**SUBJECT:** NuScale Power, LLC Response to NRC Request for Additional Information No. 9172 (eRAI No. 9172) on the NuScale Topical Report, "Evaluation Methodology for Stability Analysis of the NuScale Power Module," TR-0516-49417, Revision 0

## Response to Request for Additional Information Docket: PROJ0769

**eRAI No.:** 9172

### **NRC Question No.:** 01-59

Figure 1: Diagram of the CVCS

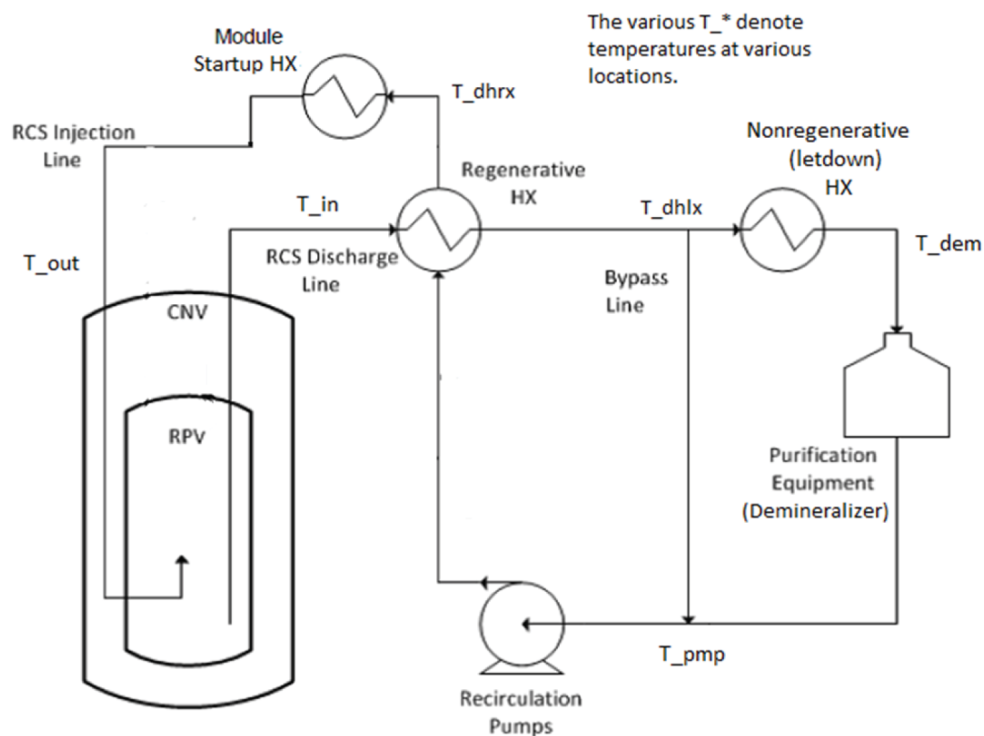
In order to make an affirmative finding associated with the above regulatory requirement important to safety, NuScale should provide a detailed description of the CVCS model in PIM that includes: a list of the components of the CVCS, a flow diagram, and equations describing how flow rates and fluid temperature are computed by PIM.

The NuScale chemical volume and control system (CVCS) is simple in design and is not required to function during or after an accident. During normal operation, the CVCS recirculates a portion of the primary coolant through demineralizers and filters to maintain primary coolant cleanliness and chemistry. A portion of the recirculated coolant is used to supply the pressurizer sprays for controlling reactor pressure. Primary system coolant inventory is controlled by injection of additional water when the primary coolant levels are low or letdown of primary coolant to the liquid radioactive waste system when coolant inventory is high. Additionally, during the module start-up process, the CVCS is used to add heat to the primary coolant via the module heatup heat exchanger to establish natural circulation flow in the primary coolant system. A diagram of the CVCS is provided in Figure 1.

Relative to Figure 1, PIM has the following simplifications regarding the CVCS.

In PIM, the CVCS is modeled by withdrawing letdown at a user-specified flow rate from a user-specified node in the downcomer at the local node conditions, passing the extracted fluid through the CVCS heat exchangers and pumps, and returning charging flow to a user-specified node in the riser. The fluid mass and energy are added to the node via calculations within PIM. No credit for the momentum transfer from the injected flow is taken that might increase the primary loop flow. Letdown flow and charging flow are each lagged by 10 seconds to represent the delaying effects of flow through long pipes.

The CVCS model in PIM is discussed more below. The variables used in the discussion below are listed in Table 1, which relates the variables to locations of Figure 1. Enthalpies and temperatures are related via a state call that assumes subcooled liquid at the RCS pressure.
